## Planning Commission Staff Report

July 24, 2013  
Item 6.a.

- SUBJECT:** Work Session for PUD-84
- APPLICANTS/  
PROPERTY OWNERS:** Frank and Barbara Berlogar
- PURPOSE:** Work session to review and provide comments on an application for planned unit development (PUD) development plan approval to subdivide an approximately 37.4-acre site with up to four lots, consisting of three new single-family lots for custom homes and one lot with the existing residence.

- LOCATION:** 88 Silver Oaks Court
- GENERAL PLAN:** Residential – Low Density (less than 2 dwelling units per gross acres) and Open Space – Public Health and Safety

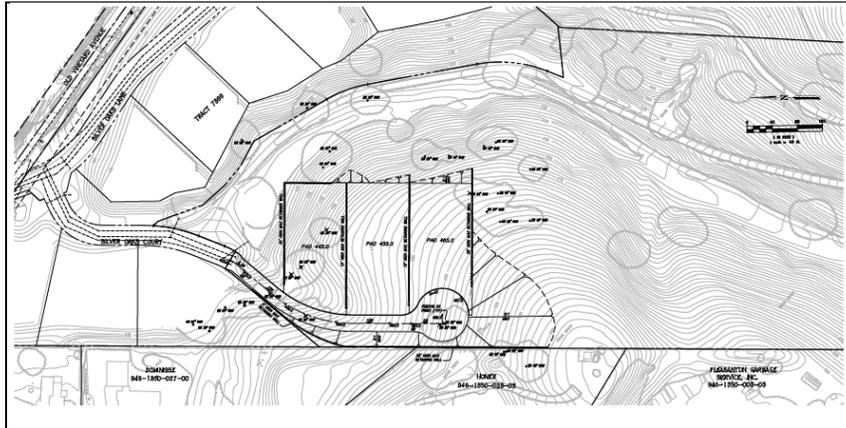
As shown in the exhibit above, the proposed Lot 1 and a portion of the proposed Lot 2 would be located within the “mustard colored” area as identified in the VACSP Land Use Plan for hillside residential development.

The VACSP indicates that all hillside home sites must be located within the designated development areas as generally depicted (underline added) on the land use plan, the “mustard colored blob” as it was referred to. Staff notes that the land use plans are not usually meant to be precise, but can be flexible.

The Silver Oaks Estates HOA stated in its letter that locating lots/homes outside the “blob” area would not conform to the VACSP or the specific plan’s Environmental Impact Report. If the proposed lots/homes are located entirely within the “blob” area such as the lot layout shown in one of the site alternatives (discussion later in the report), heritage-sized trees would be removed, significant grading would be required, and tall retaining walls would be constructed.

Staff believes that the proposed development plan conforms to the intent of the Specific Plan. Staff notes that land use plans are generally considered conceptual, thereby providing flexibility for the development of actual projects. Staff believes the “blob” or “dot” is conceptual and is not intended to be specific at the time these plans were made. For the seven custom home sites in the nearby site (PUD-54) on Lot 25 of the VACSP, the Commission and Council allowed some of the hillside residential home sites to be located outside the area shown on the Land Use Plan without a Specific Plan Amendment. Likewise, staff believes that the proposed lots could be located within the general vicinity of the location shown on the land use plan without a Specific Plan Amendment.

## Alternative No. 1 – Three New Residential Lots

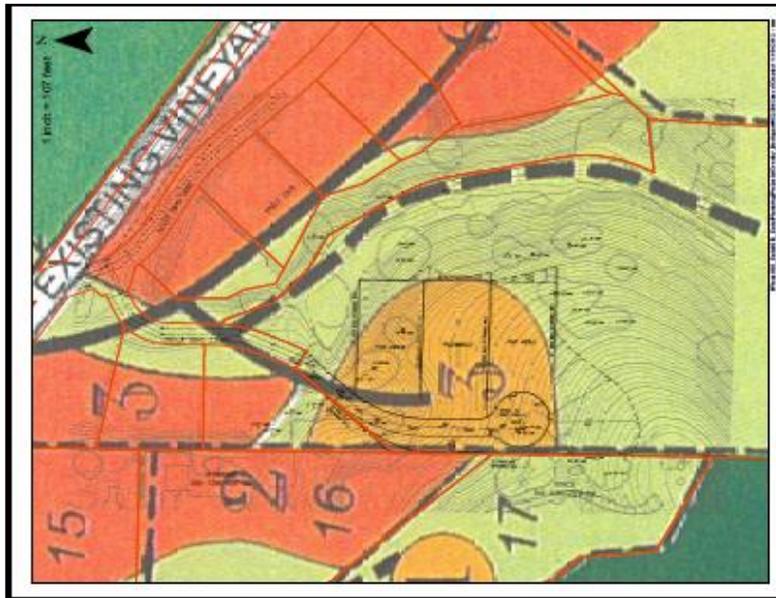
- Except for a small portion of Lot 1 and Lot 3, this three-lot site alternative fits inside the Hillside Residential area as depicted in the Specific Plan's Land Use Plan;
- The slope of the road varies from 6% to 19%;
- An eight-foot high retaining wall is needed along the west side of the proposed road;
- Retaining walls varying between 10- to 25-foot in height are located between the residential lots;
- Eight heritage-sized oak trees would need to be removed;
- Pad elevations for the three new lots are: Lot 1 at 445'; Lot 2 at 455'; Lot 3 at 465';
- Lot sizes of the three new lots are: Lot 1- approx. 19,795 sq.ft.; Lot 2 – approx. 21,025 sq.ft., Lot 3 – approx. 18,117 sq.ft.
- The total area of disturbed slope is approx. 98,843 sq.ft.

From the proposed alternatives, Alternative No. 1 may be revised slightly so that all three new residential lots would fit within the Hillside Residential area and responds to HOA's concern of compliance to the specific plan. However, this alternative would result in significant grading and retaining walls, and would remove eight heritage-sized oak trees. It may not address the disruptive visual impacts raised by the Silver Oaks Estates HOA in terms of retaining walls and intrusive privacy issue from the proposed three new homes to the existing homes on Silver Oaks Lane.

## Alternative No. 2: Two New Residential Lots

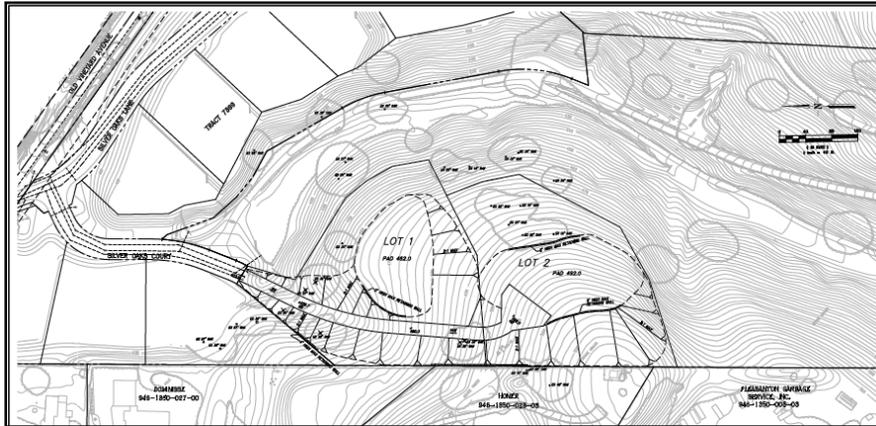
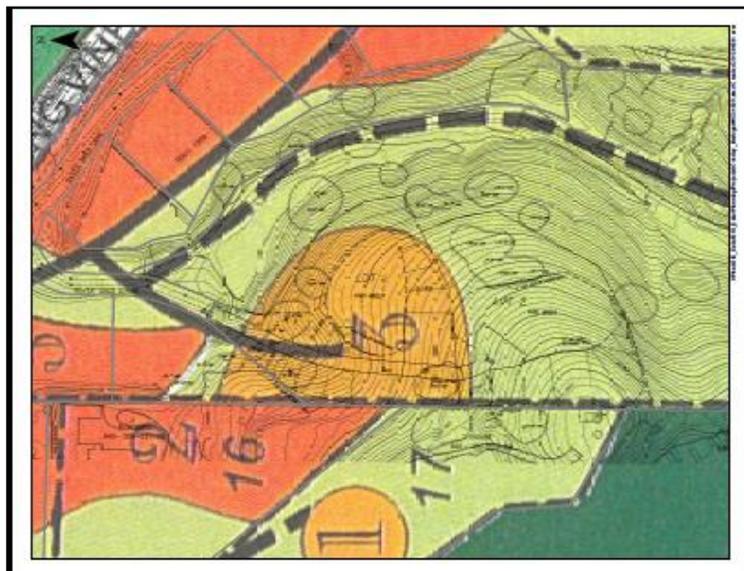
- Two new residential lots with most of Lot 2 outside the Hillside Residential area as depicted in the Specific Plan's Land Use Plan;
- The slope of the road varies from 6% to 12%;
- A four-foot high retaining wall is needed along the west side of the proposed road;
- A two-foot high retaining wall is needed on Lot 1;
- Two retaining walls, 5 and 6 feet in height, are needed on Lot 2;
- Six heritage-sized oak trees would need to be removed;
- Pad elevations for the two new lots are: Lot 1 at 462'; Lot 2 at 492';
- Building envelope area for the two new lots are: Lot 1 – approx. 17,140 sq.ft., Lot 2 – approx. 21,938 sq.ft.
- The total area of disturbed slope is approx. 107,541 sq.ft.

Neither Alternative No. 2 nor Alternative No. 3 fits within the Hillside Residential area. The proposed road on Alternative No. 2 is very steep, exceeding the maximum slope which is acceptable to the Fire Department. Both alternatives would result in removal of several heritage-sized oak trees.

### Alternative No. 3 – Two New Residential Lots

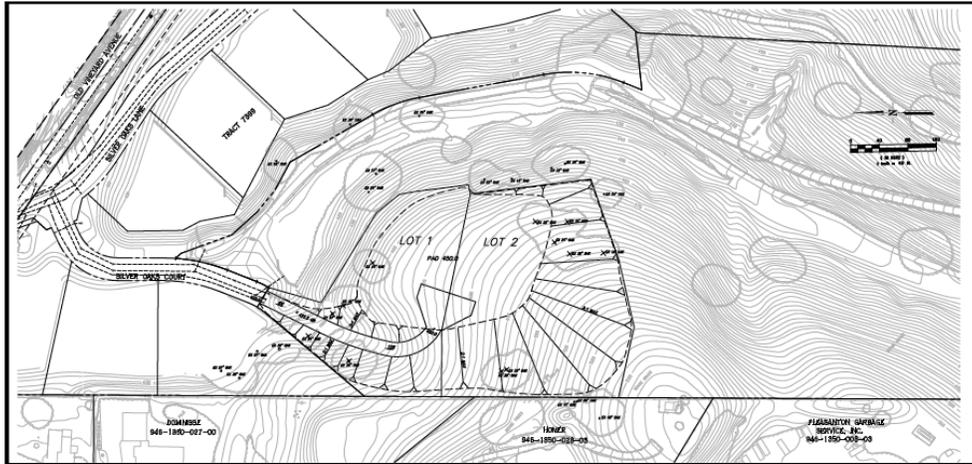
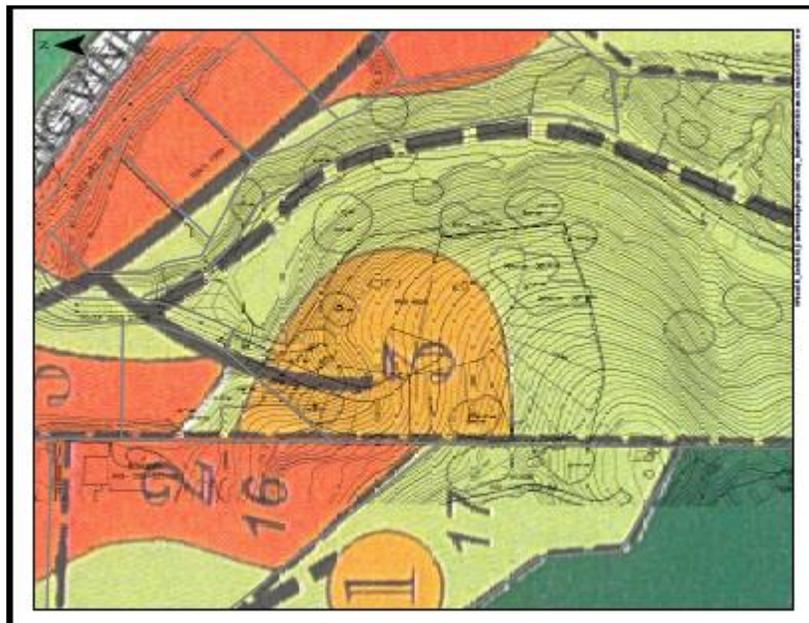
- Two new residential lots with Lot 2 partially outside the Hillside Residential area as depicted in the Specific Plan Land Use Map;
- The slope of the road varies from 6% to 12%;
- No retaining walls are proposed;
- Six heritage-sized oak trees would need to be removed;
- Pad elevation for both lots is at 450'.
- Building envelope area for the two new lots are: Lot 1 – approx. 21,974 sq.ft., Lot 2 – approx. 20,621sq.ft.
- The total area of disturbed slope is approx. 107,037 sq.ft.

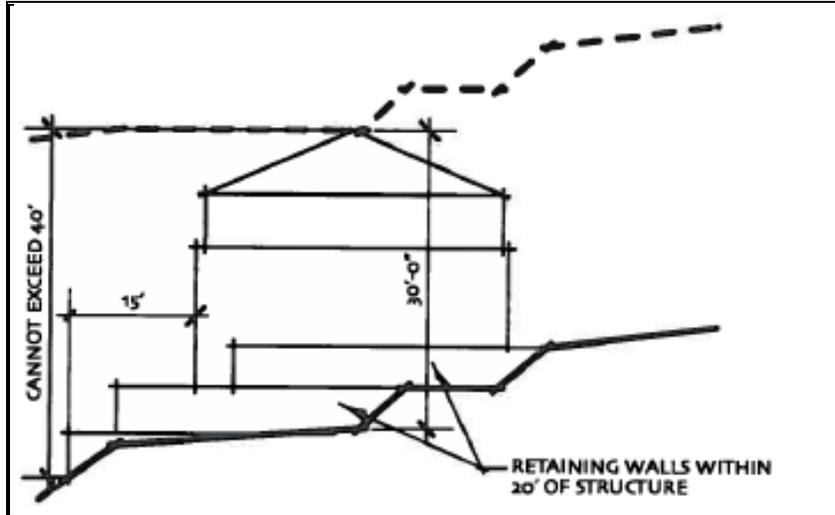
The home on Lot 1 would be a split-level home to minimize grading; thus, the proposed house pad on Lot 1 would be located on elevations of 460 feet and 470 feet, and the proposed house pad on Lot 2 would be located on elevation 515 feet. The proposed home design guidelines require the homes to be designed to integrate into the hillside setting or a split-level design. Regarding height, the design guidelines require, at any point on the plane of any visible elevation, the height of the structure, measured from the existing grade to the highest point of the finished roofing, shall not exceed 30 feet. The overall height of the structure, measured

from the lowest natural grade when the house is constructed to the highest point of the finished roofing, shall not exceed 40 feet. See illustration below (pg. 12 of the proposed design guidelines, Exhibit B).

**Discussion Point No.3:** Is the proposed building height specified in the design guidelines acceptable?
